May 18, 2023

Re: Structural Inspection  
Brimfield Town Hall Annex & Town Hall Buildings

Re: Structural Review  
Town Hall Annex  
Brimfield, MA

Photograph #12 (Town Hall Annex)  
– Leaning Side Wall

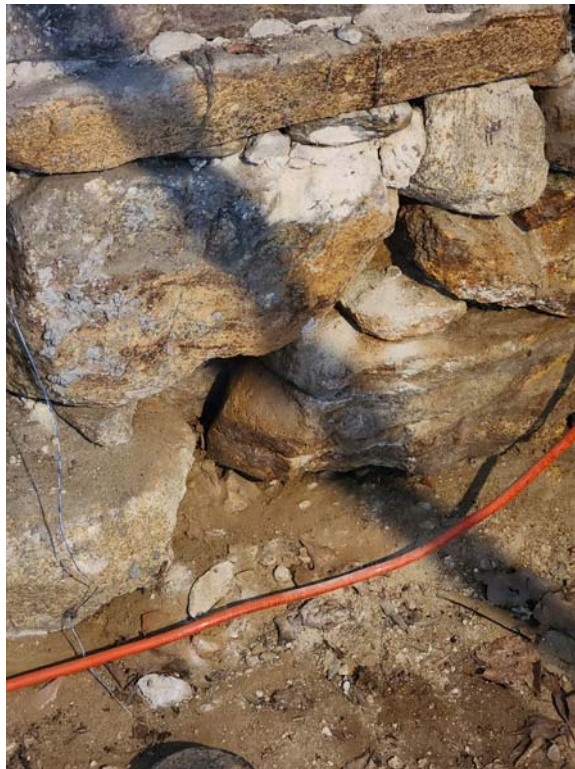
As noted in JSE's 2016 report, the front wall is bowed and appears to have an inward lean (see photographs #10 and #11). It was observed during the most recent site visit that the exterior wall along the left side of the building (when viewed from Main Street) also has an inward lean (see photograph #12). Using a laser measurer, it appears that this wall is around 4" to 5" out of plumb. There has also been settlement in the exterior grade at this corner of the building as evidenced by the exterior stairs (see photograph #13).

Photograph #17 (Town Hall)  
– Interior Water Damage

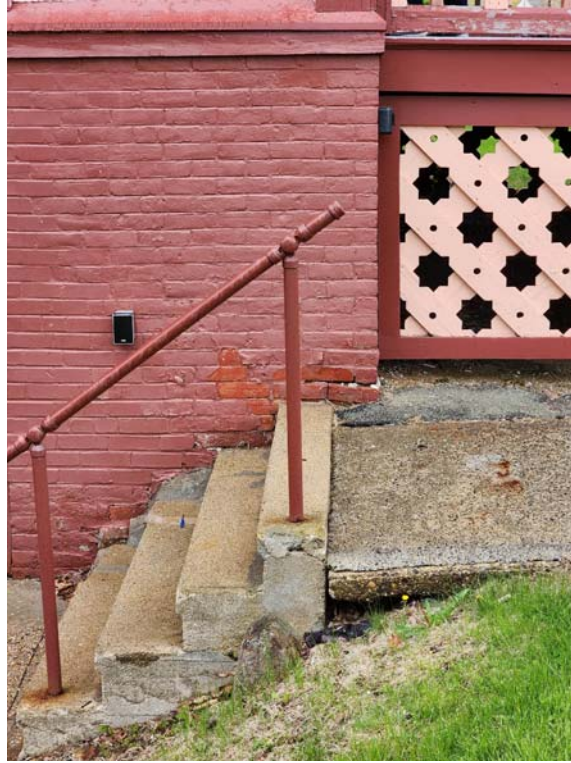
- There are signs of water damage at the second floor level (see photograph #17).
- The low, flat roof in the rear of the building is in poor condition (see photograph #18).

Photograph #32 (Town Hall)  
– Gaps at Truss Member Joint

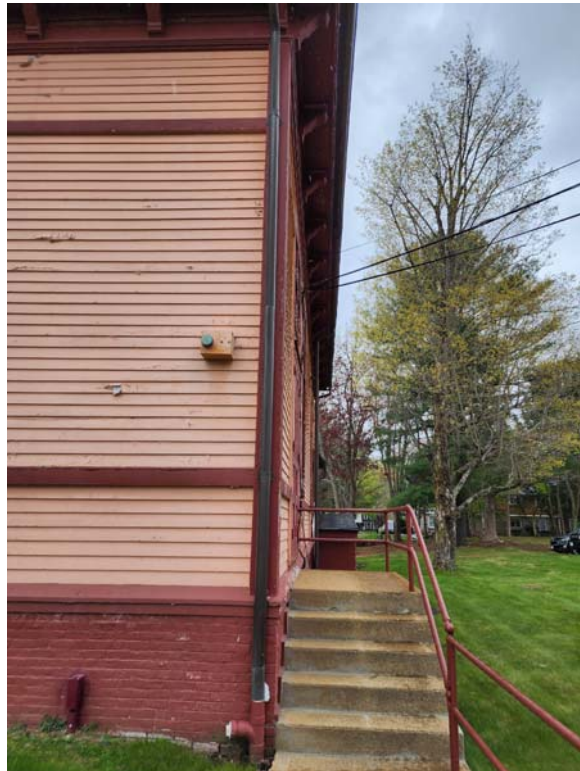
- The timber members comprising the roof trusses are severely split (see photographs #25 through #28).
- There has been a lot of movement within the roof trusses. Large gaps have formed at the member joints (see photographs #29 through #33). Wood shims were installed at some of the joints to fill the gaps (see photograph #34).

Photograph #19 – First Floor Shoring Jacks

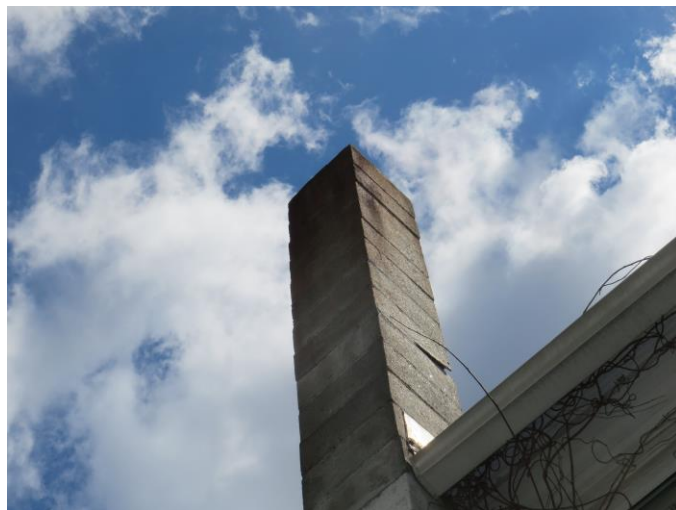
15. Temporary screw type shoring jacks were previously installed throughout to support the first floor framing (see photograph #18.1). Some of the shoring jacks were installed along the length of various joists and beams, and some were installed below beam connections. The shoring jacks bear on cinder blocks and stones (see photograph #19). Note that temporary screw type shoring jacks are not meant to be used as permanent supports.

Photograph #24 – Bowed Front Exterior Wall

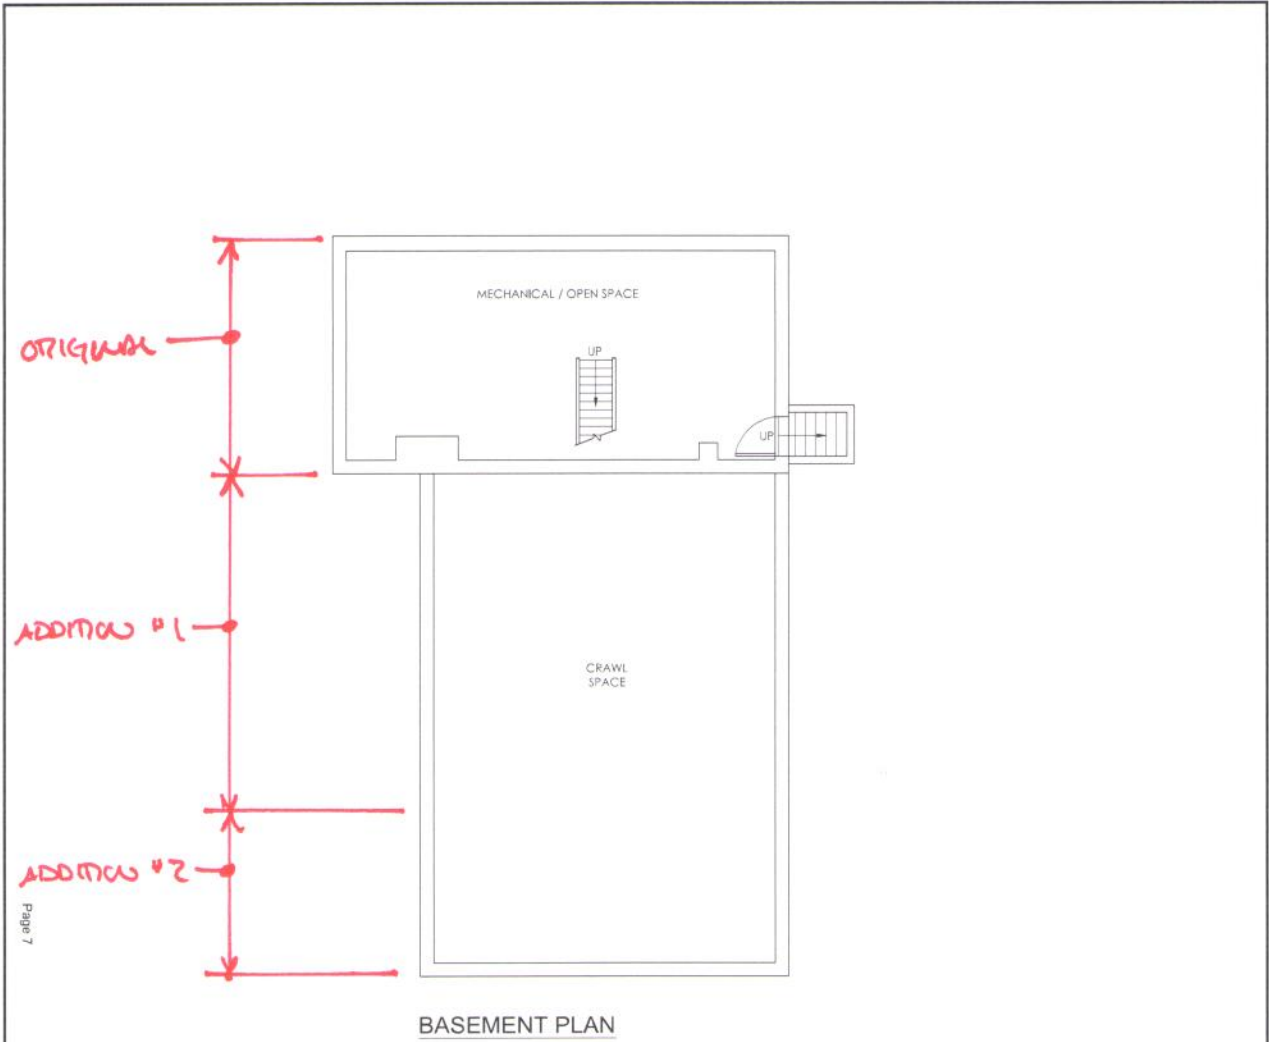
19. There is a large bow in the front exterior wall adjacent to the front door (see photograph #24 and #25).

EXISTING TOWN HALL ANNEX BASEMENT PLAN

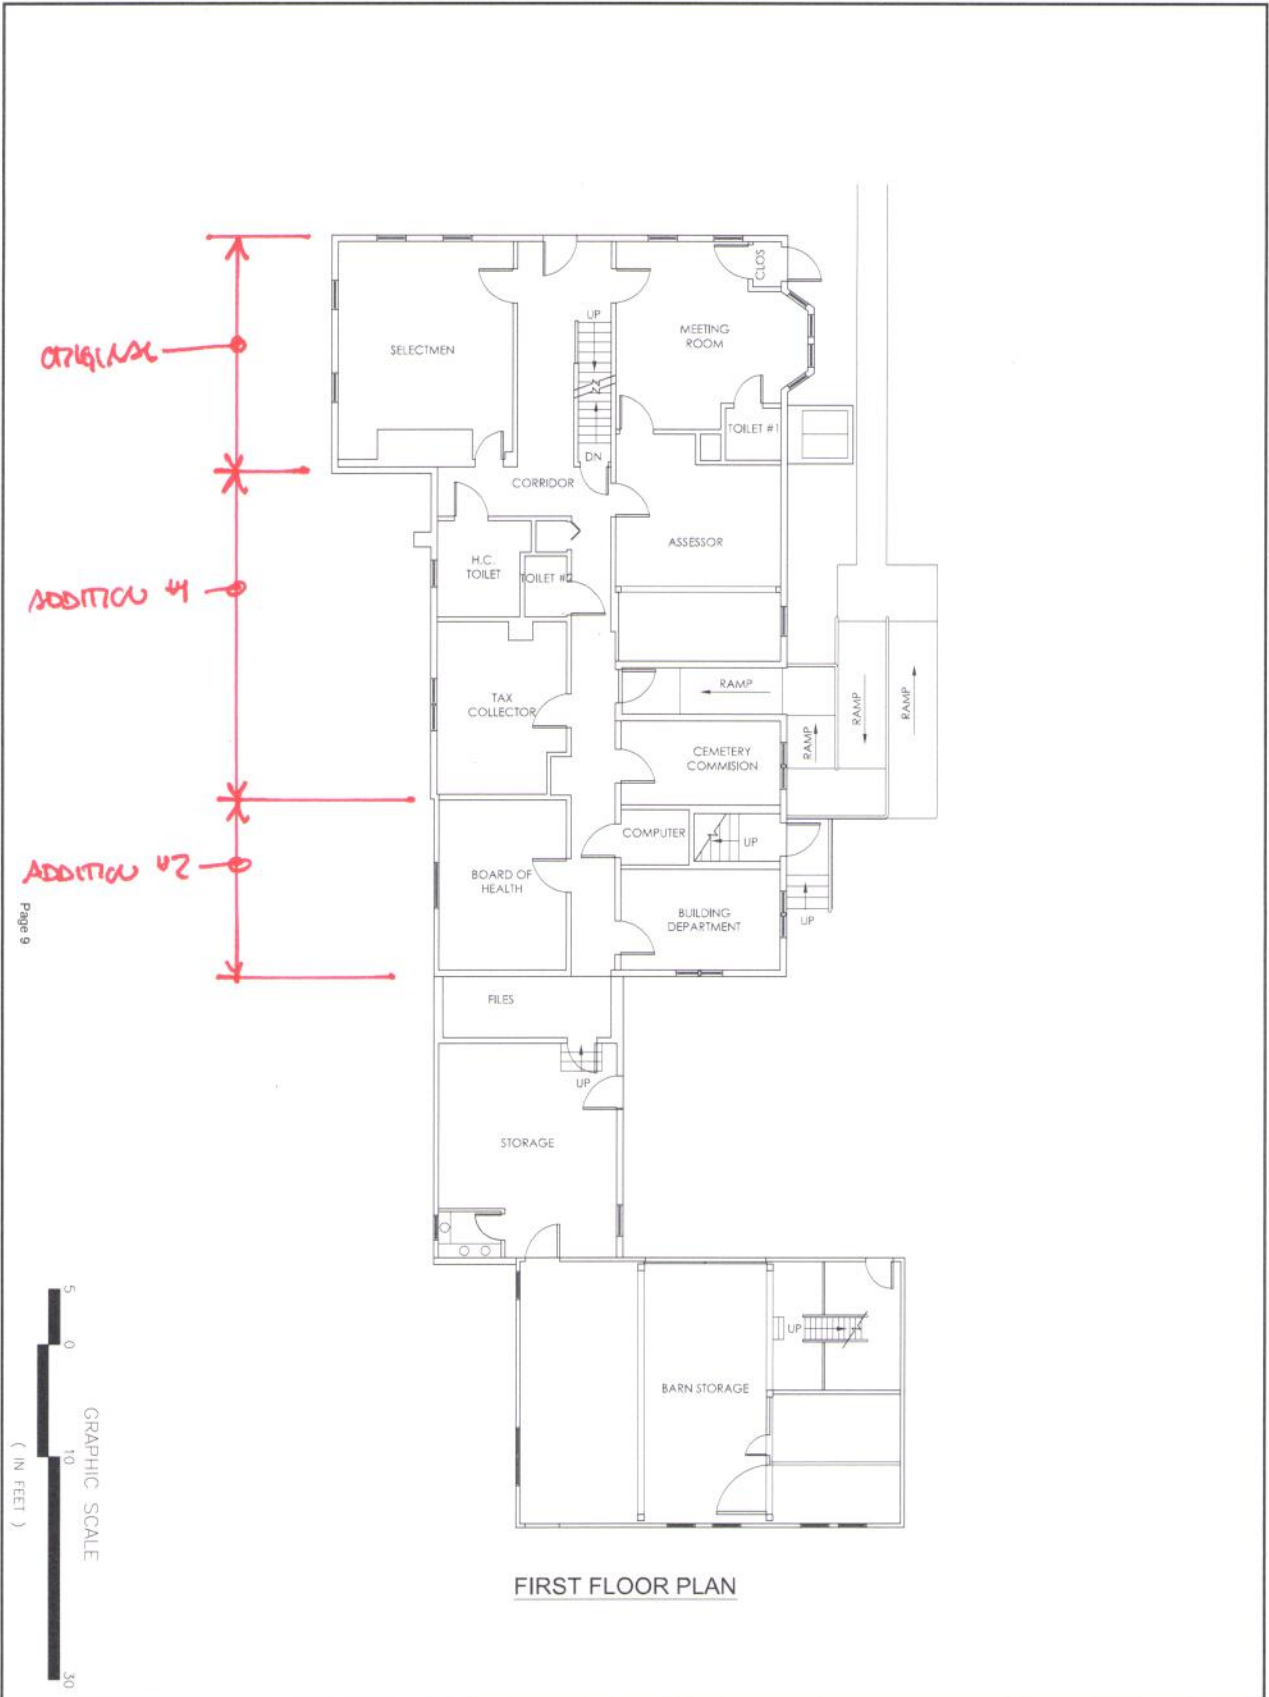
The following list summarizes the issues that were discovered during the site visit. Please reference the attached markups for the locations of the rooms referenced in the list.
